To: Mayor and Council
RE: Staff Review –Lot 1, Village West
Commercial Corridor Overlay Hwy85/Hwy 16
Number of Variances requested: 6

The applicant has submitted a variance application for relief from Commercial Corridor Overlay standards.

LOT 1 @ VILLAGE WEST

REAR ELEVATION
 1/8"=1'-0"

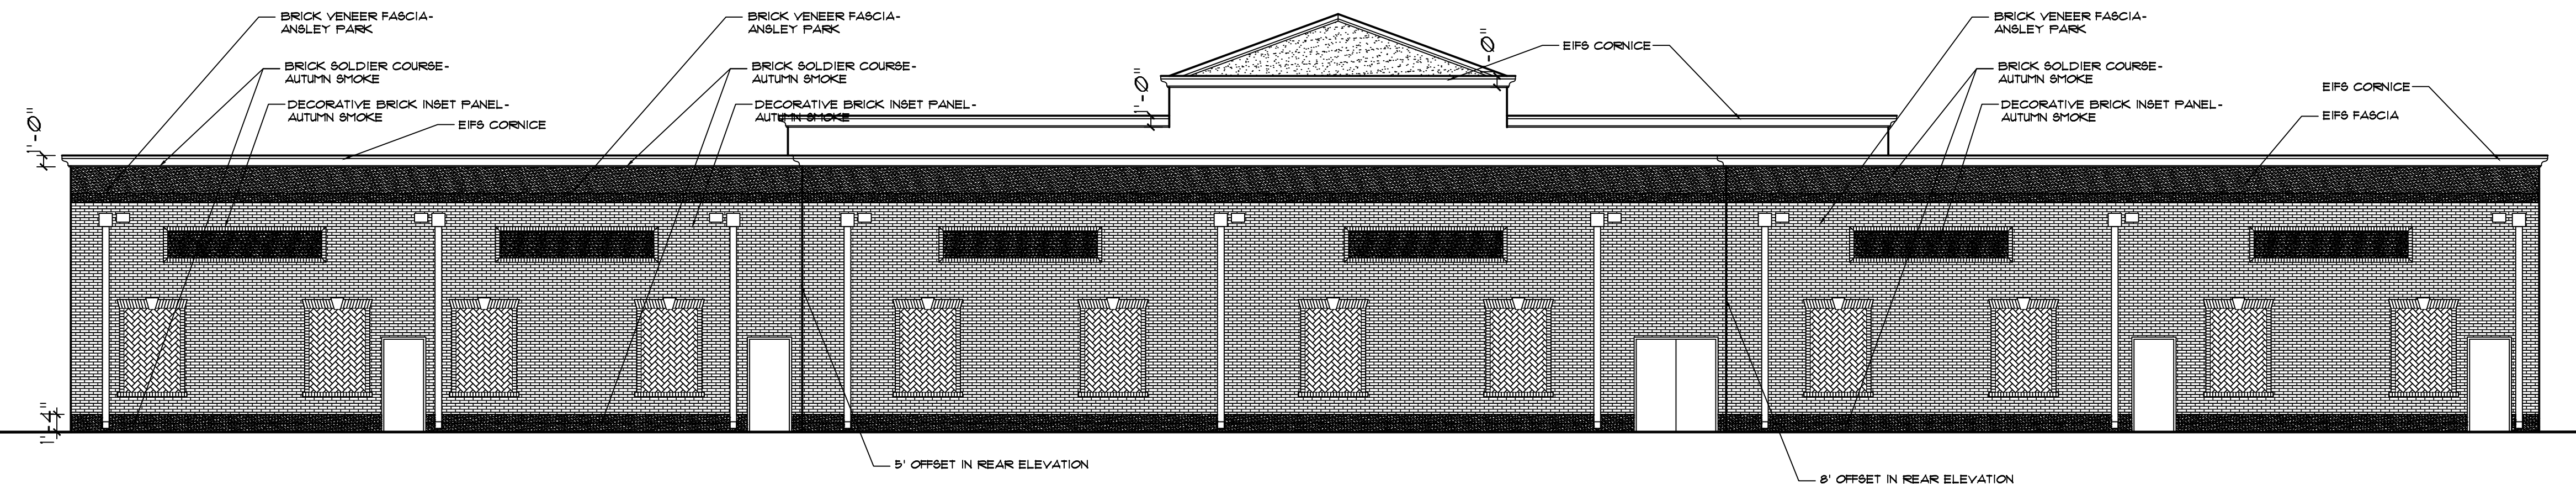
- Consider approval of the variance to allow a blank windowless wall on the rear elevation with false windows as presented on the updated elevations.
- Consider approval of the variance to allow the storefront elevation to be 47 percent windows on the primary façade and 3 percent windows on the secondary facades, as presented on the updated elevations.
